Case No.: SC-2014-0214
WC-2014-0215

OSAGE WATER COMPANY’S RESPONSE TO STAFF’S STATUS REPORT

**REVIEW OF THE
SEWAGE COLLECTION SYSTEM
AND
TREATMENT PLANT**

EAGLEWOODS SEWAGE TREATMENT PLANT

Figure 13-Leaking Under Sand Filter Bed, During July 1, 2016

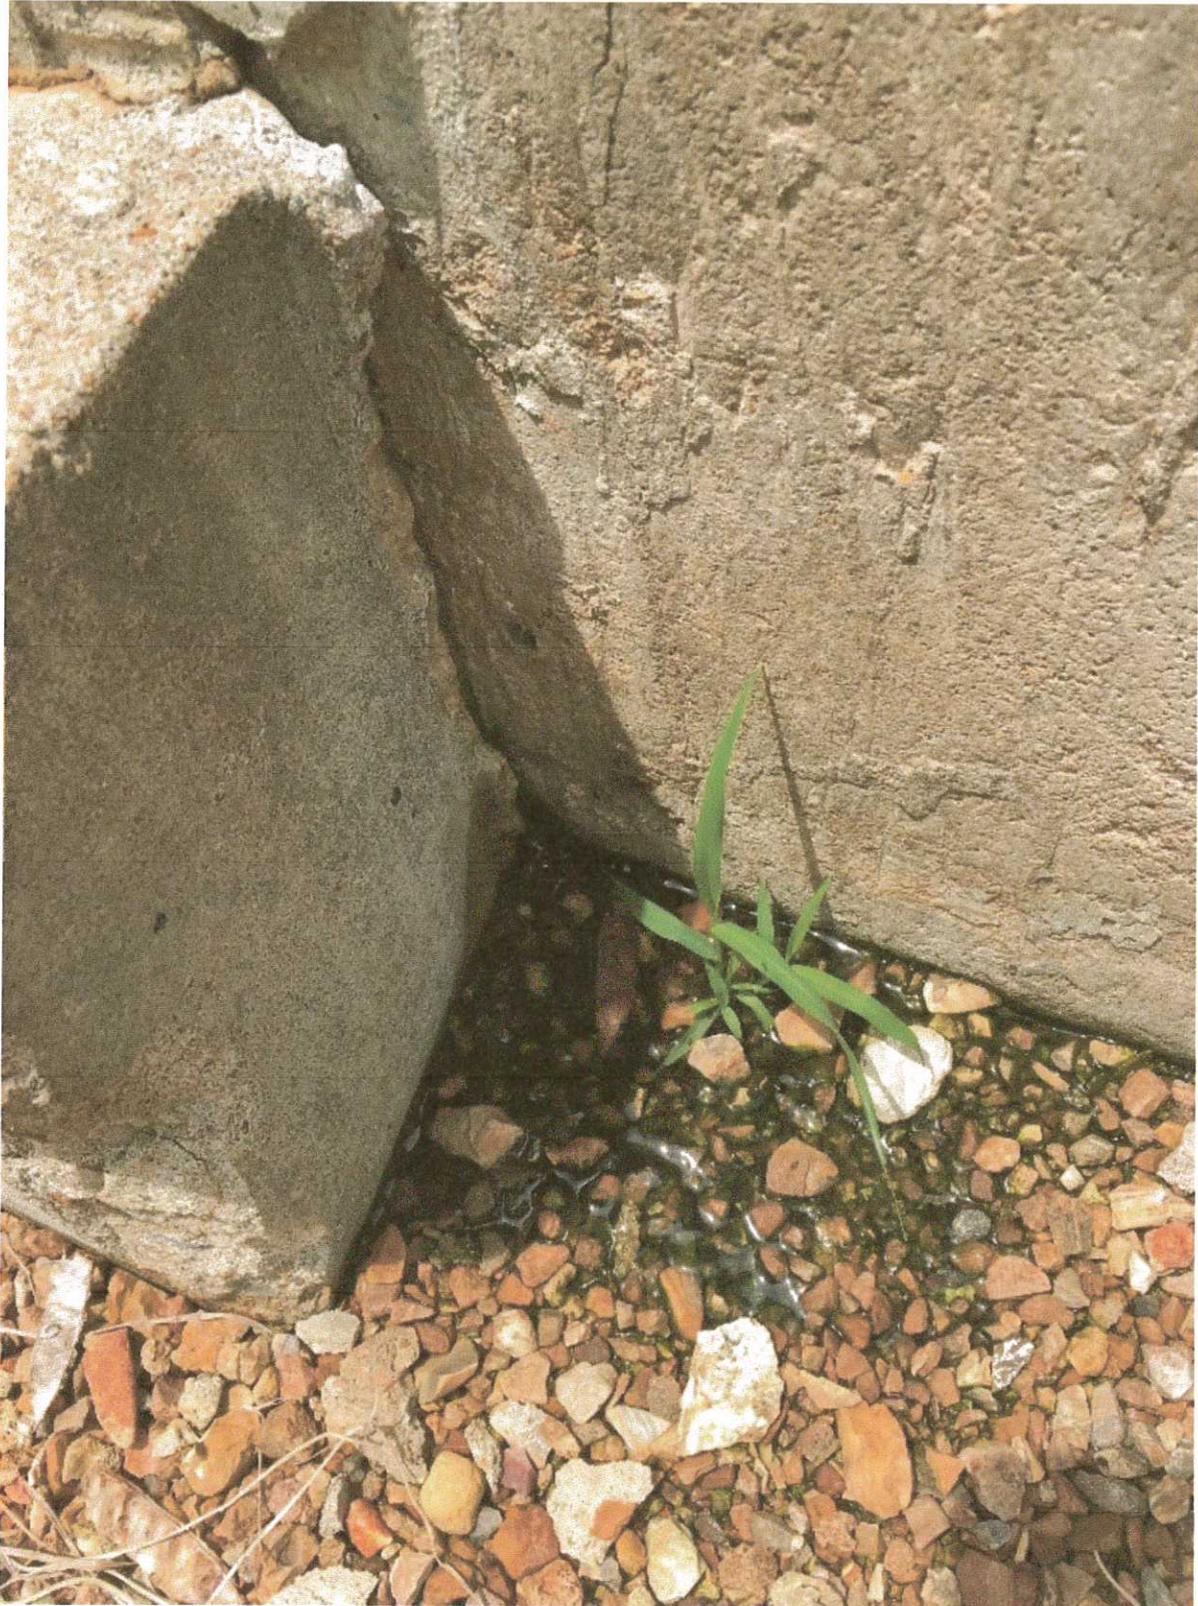
In addition to the recirculating filter beds being over capacity, they are also in a state of disrepair. During both site visits on January 30, 2016 and July 1, 2016, the treatment plant was leaking water through cracks down the sides of the concrete walls as well as water could be visibly seen bubbling up along the footing of the bed allowing partially treated sewage to run into the nearby stream.

The filter beds were constructed in such a way that one wall is below grade. Although this is a common practice, the wall below grade could not be inspected for cracks and it should be assumed that it is in the same shape as the three (3) visible walls. This would lead to believe that the treatment plant is actually leaking more than what can be seen.

The filter bed, recirculation tank, chlorinator, and chlorine contact tank are all of inadequate size to handle the existing flow. Due to the condition of the recirculating filter beds, recirculation tank, chlorinator, and chlorine contact tank, it is recommended that they be scrapped and a new treatment plant be constructed further up the hill so to be removed from the flooding effect of the nearby stream. It is also recommended that the treatment plant be replaced and an additional filter bed of thirty feet by forty-two feet (30' x 42') be also constructed for additional flow which may be generated by the future development in the subdivision. This treatment plant reconstruction will cost an estimated \$350,000 and reconstruction with an expansion of one (1) additional filter bed is estimated at \$525,000

Figure 5-Large Crack Down Corner of Sand Filter Bed

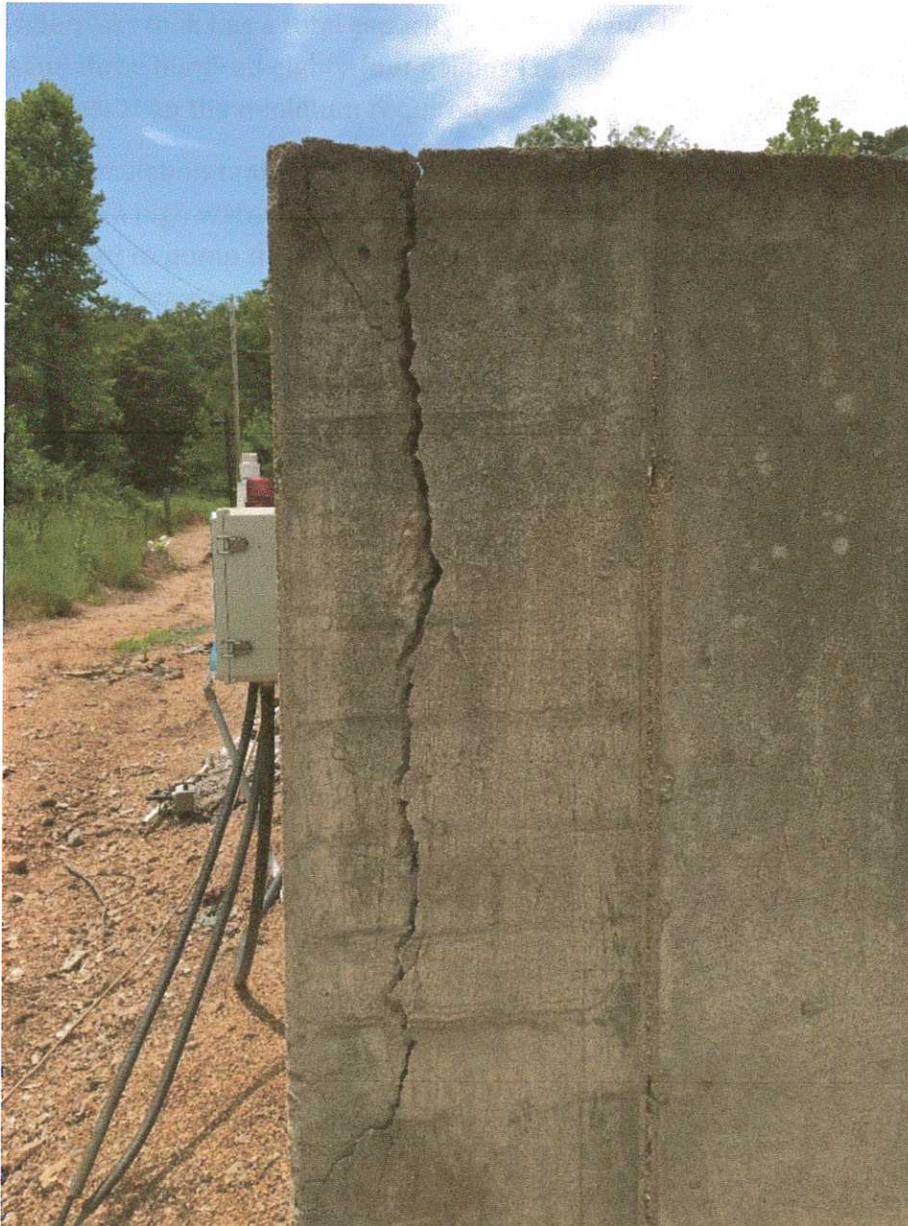
There is also a large crack running down the southern corner of the eastern wall of the treatment plant. This crack is nearly one half inch (1/2") wide and is an indication that either the southern wall, the eastern wall, or both could fail catastrophically in the future. Although the crack did not show signs of leaking during either site visits, a leak should be expected to form from this size of a crack.
